RFI #Constr-412: CS - Deletion of Bulletin 2 Roof Duct Enclosure Under Dunnage

RFI #Constr-313: CS - Roof Ductwork and Dunnage Coordination

Subject: Roof Ductwork vs Dunnage
Discipline: Sheet Metal
Specification Section: 2331000
Drawing No: M1.00-CS, M1.11-CS

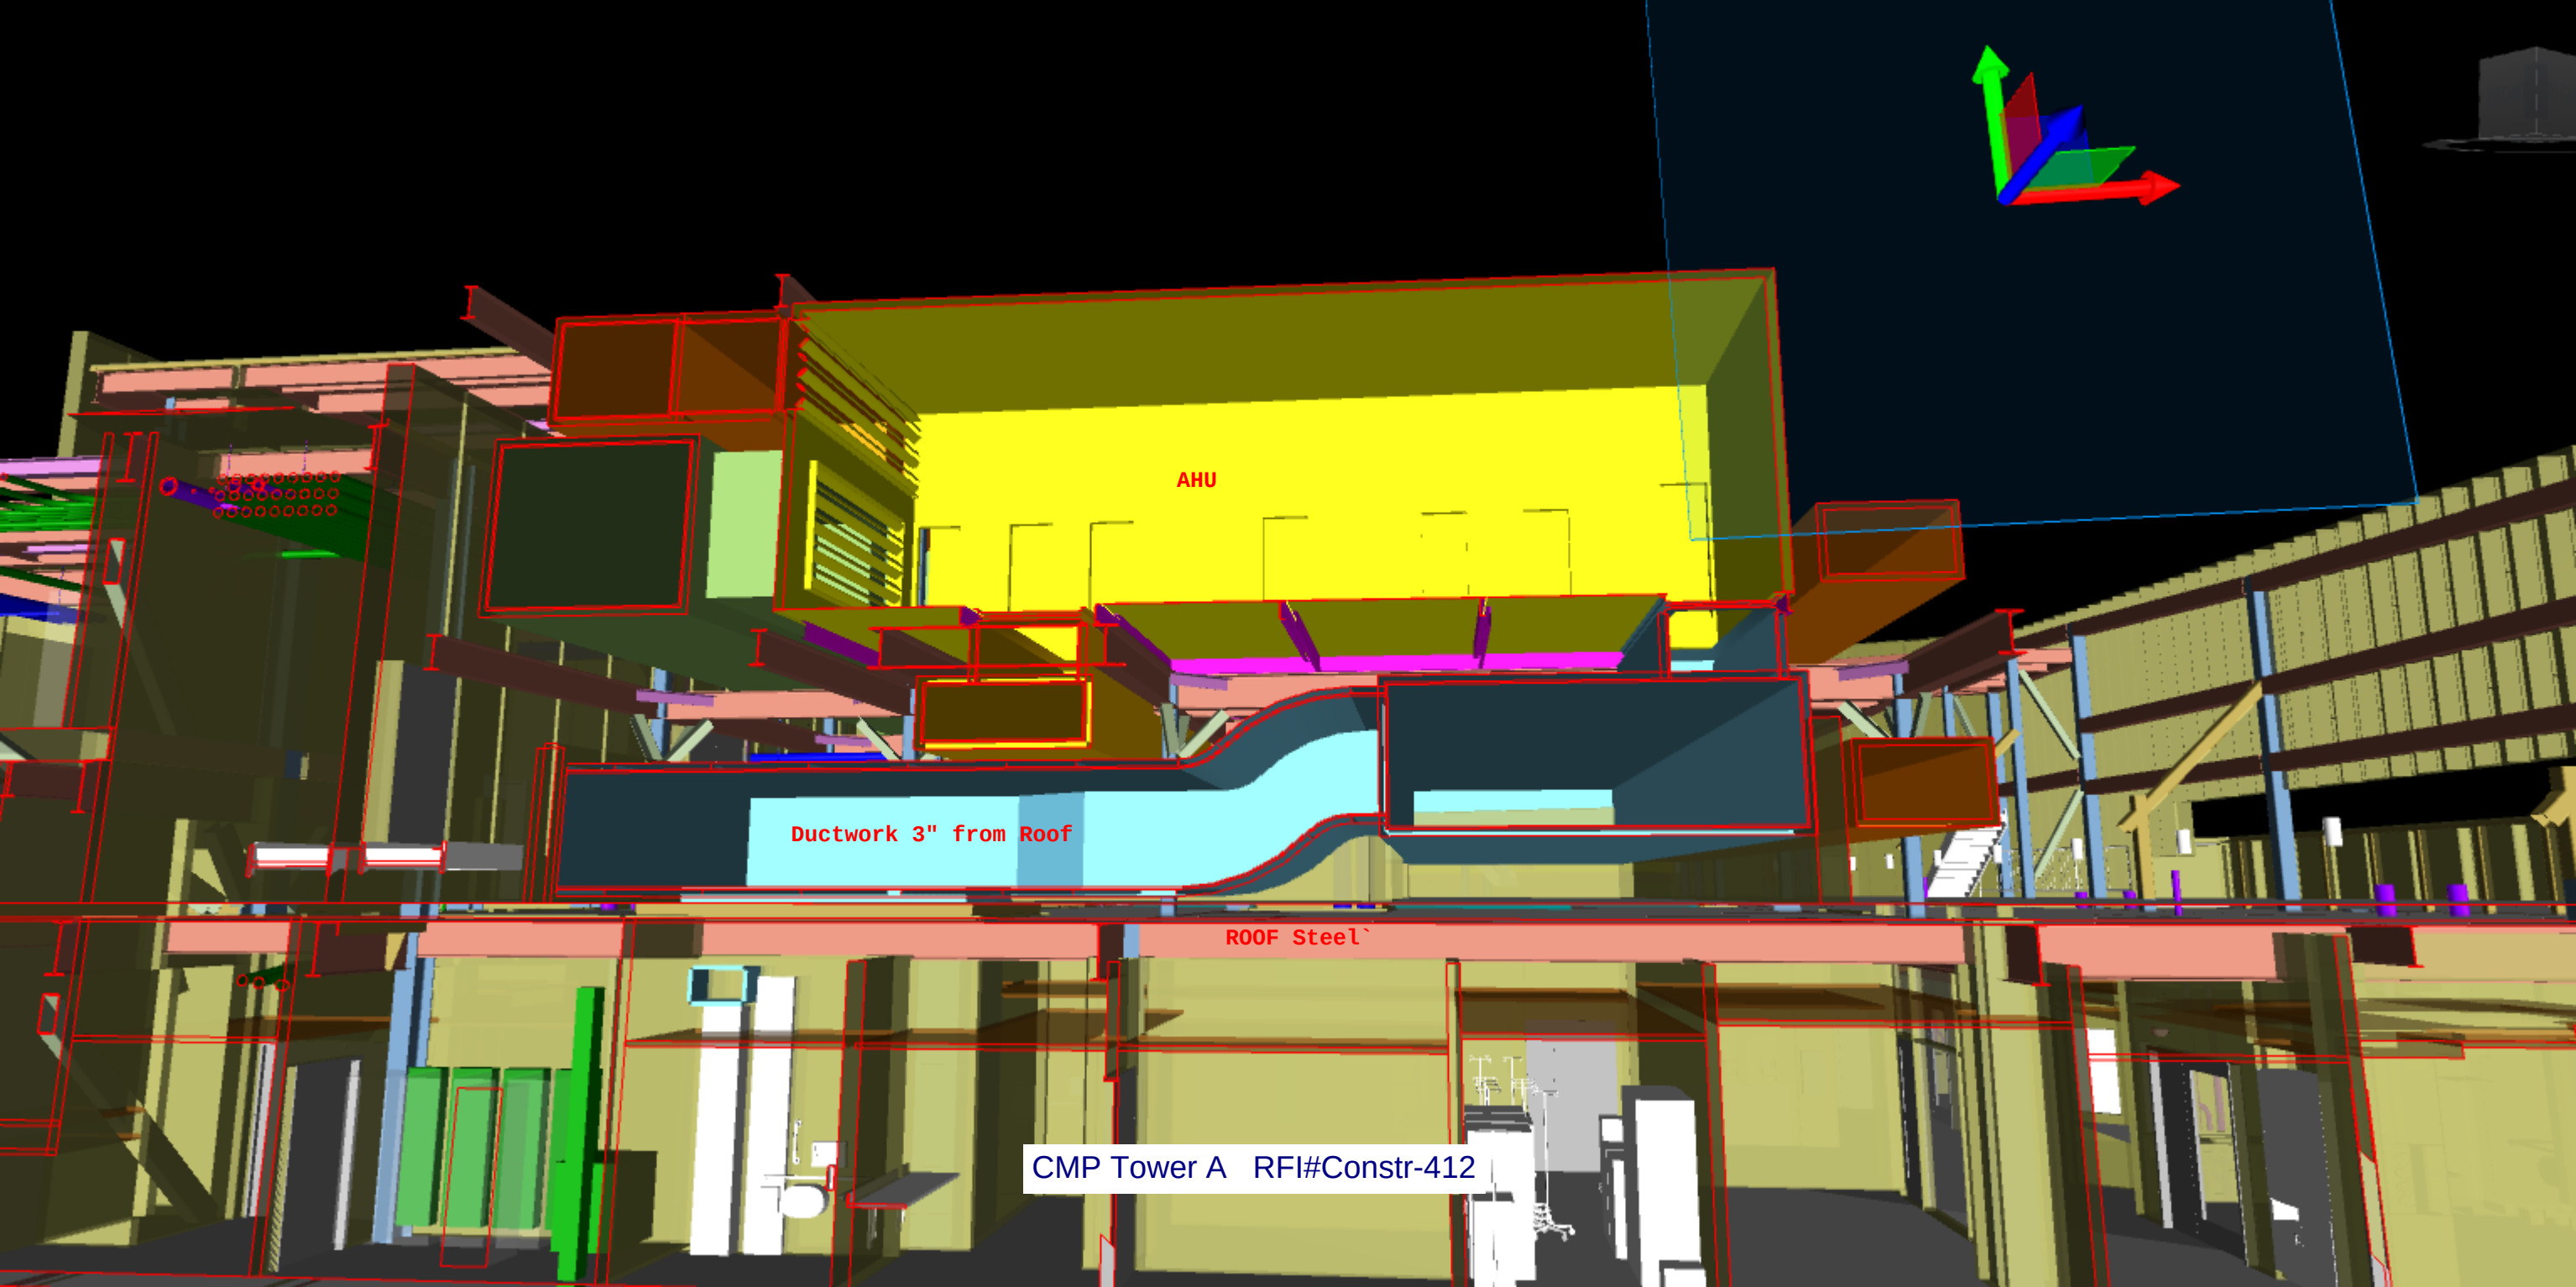
Question: The Ductwork for the Rooftop AHU under the dunnage needs 36" for the installation of the Duct Curbs for the Vertical Risers to be installed off the bottom of the ducts. The amount of space currently in the model is 3" from the ductwork to the roof. See attached snips of the current design.

Suggested Solution: Raise the Dunnage at Least 36" to allow for the installation of the duct curbs for the riser ductwork.

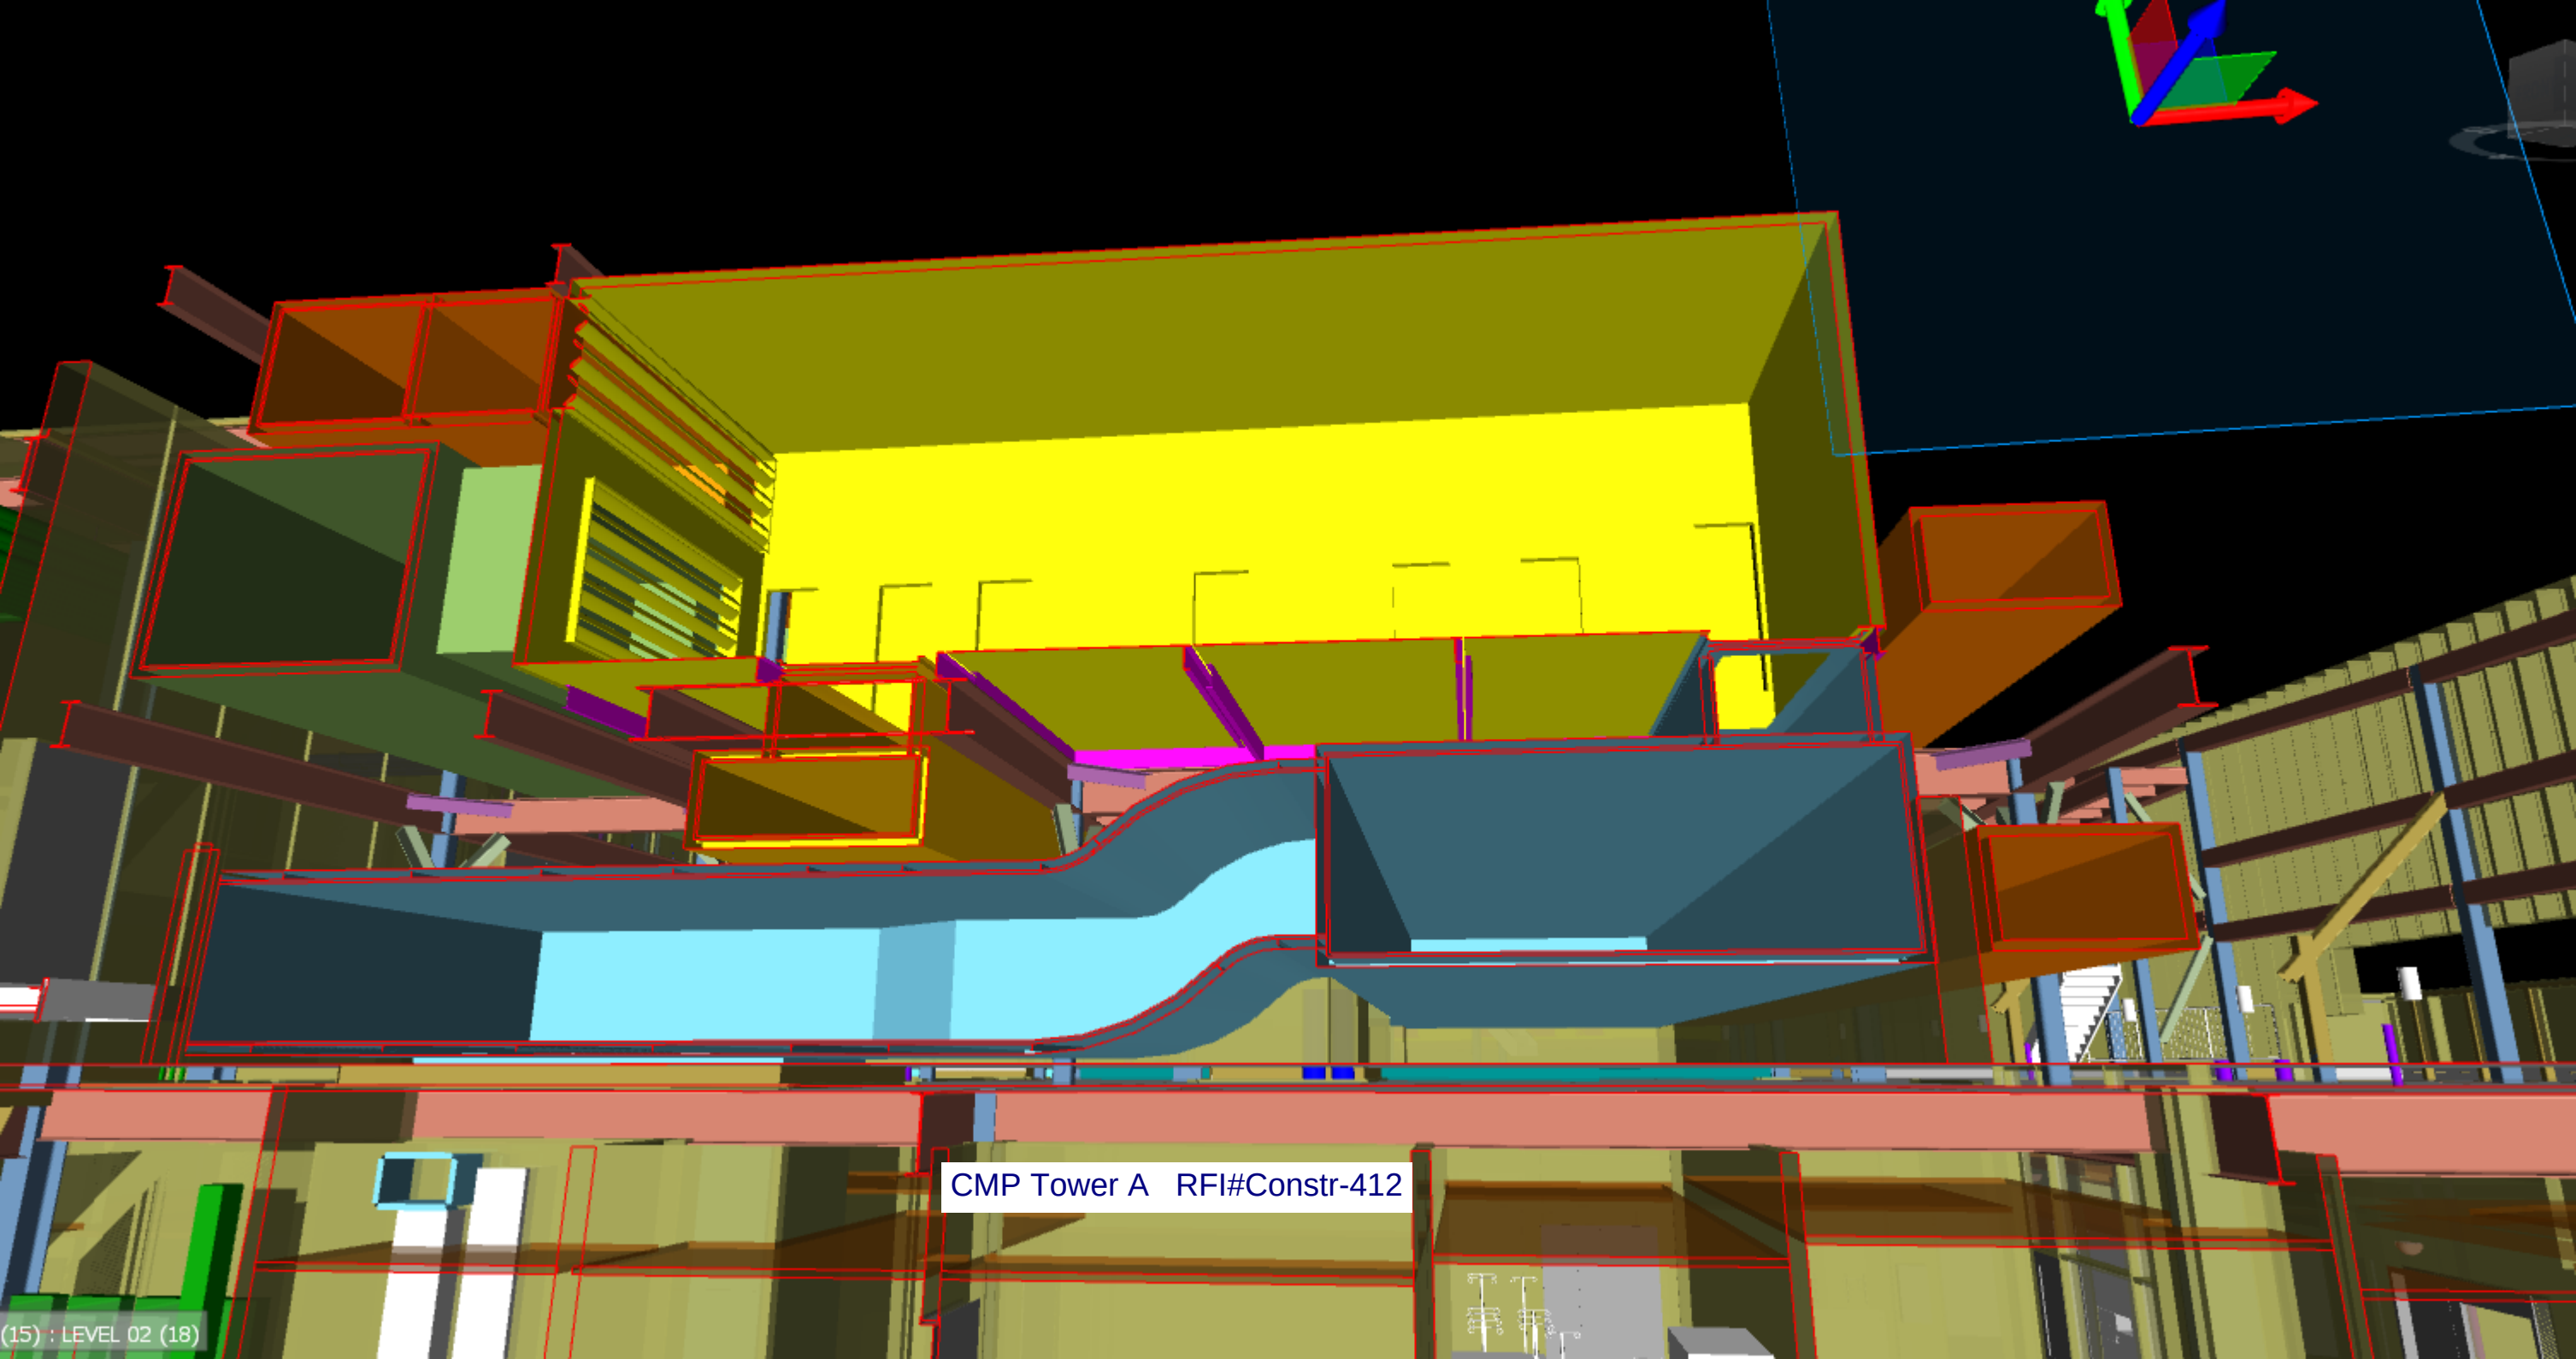
AHU

Ductwork 3" from Roof

R00F Steel
